Access Compliance Report

Public Rights-of-Way

(Curb Ramps)

Intersection ID: 51379	Main Street: BROADRICK_BV	Cross Street: UNIVERSITY_CITY_BV	Location:	N
ADA ID: AFFE2FAE9B75	Ramp Type: Perp	Initial Pass/Fail: Fail	Overall Compliance: No	Severity Score: 25
Codes/Mitigation Info/Possible Solution		Field Measurements/Component Compliance

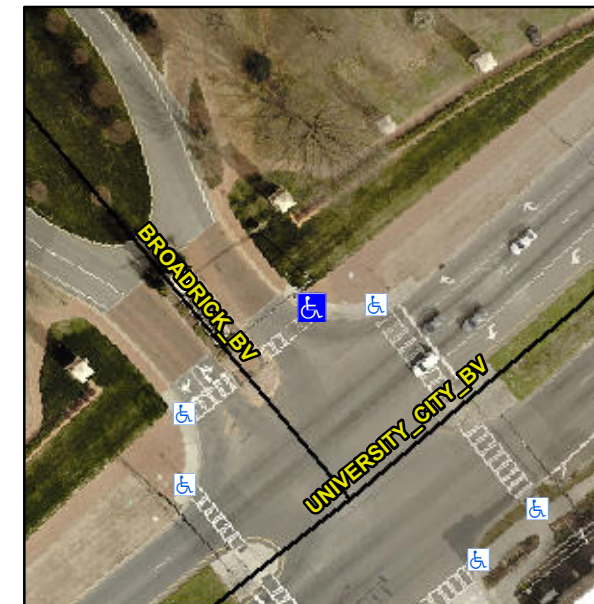
Not Found, R304.2.2

Compliance	Description	Data	Compliance	Description	Data
N/A	Ramp Length (in)	73.0	No	Ramp Slope (%)	20.0
Yes	Ramp Width (in)	52.0	Yes	Ramp XSlope (%)	1.3
N/A	Flare Type LT	N/A	N/A	Flare Type RT	N/A
N/A	Flare Slope LT (%)	N/A	N/A	Flare Slope RT (%)	N/A
N/A	Flare Traversable LT?	N/A	N/A	Flare Traversable RT?	N/A
N/A	Landing Length (in)	N/A	N/A	DWS Provided?	N/A
N/A	Landing Width (in)	N/A	N/A	DWS Contrast?	N/A
N/A	Landing Slope (%)	N/A	N/A	DWS Length (in)	N/A
N/A	Landing X Slope (%)	N/A	N/A	DWS Full Width?	N/A
N/A	Landing Curb? (Y/N)	N/A	N/A	DWS Offset (in)	N/A
N/A	Shared Landing?	N/A			
N/A	Gutter Ponding?	N/A	N/A	Gutter Slope (%)	N/A
N/A	Gutter Lip Ht (in)	N/A	N/A	Gutter X Slope (%)	N/A
N/A	Painted X Walk1?	Yes	N/A	Painted X Walk2?	N/A
	X Walk 1 Direction	To SW		X Walk 2 Direction	N/A
N/A	X Walk 1 Width (in)	75.0	N/A	X Walk 2 Width (in)	N/A
	X Walk 1 Slope (%)	2.3		X Walk 2 Slope (%)	N/A
	X Walk 1 X Slope (%)	0.7		X Walk 2 X Slope (%)	N/A

Remove & Replace Entire Ramp.
